# SANDBACH TOWN COUNCIL

## Planning Committee

Supplementary Planning Application List to be considered at the meeting to be held on Monday, 15 February 2021 at 7.00pm on Zoom (Zoom code on main agenda)

## Planning Application Number 17/4838c - Capricorn Phase 2a.

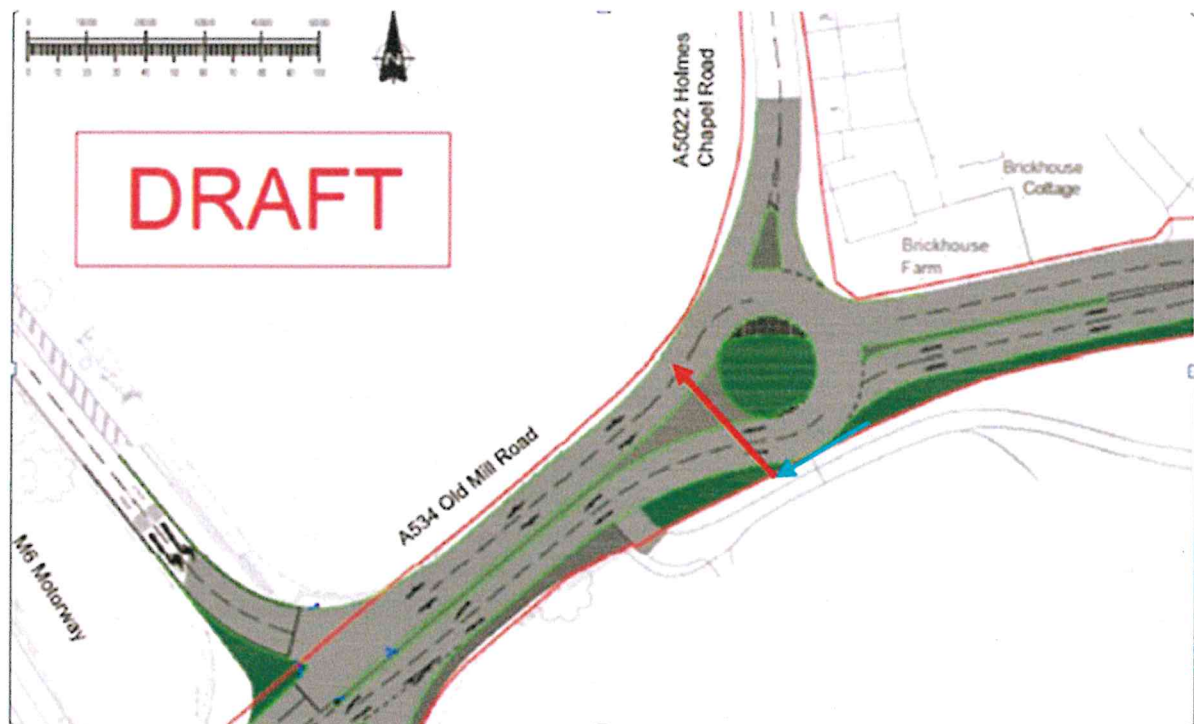
I support this though I doubt there is sufficient space to 'land' on the north side of the A534. The photo shows a grass verge, on the north side, which might be public land. However, the width of 1.5m of the central island has been identified as Problem 6.1 in the Road Safety Audit, Stage 1. The designer's response states that 'there is approximately 1.0m additional public land available to make adjustments to the island width'. I assume this refers to the grass verge which would then no longer be available for cycling.

Even if cyclists were able to 'land' on the north side and there were a shared footway for pedestrians and cyclists, there would not be a good way to join the A534 or A5022 Holmes Chapel Road again by bicycle. The grass verge gets narrower and Holmes Chapel Road has a long left hand bend.

Alternatively a crossing could be created closer to the roundabout, indicated in red below, though there does not seem to be space left for cyclists to leave the carriageway, indicated in blue, to then get to that crossing point.

This very serious problem has been addressed neither in the WCHAR nor the Road Safety Audit. I suggest rejecting both reports and accepting them only when this problem has been addressed.
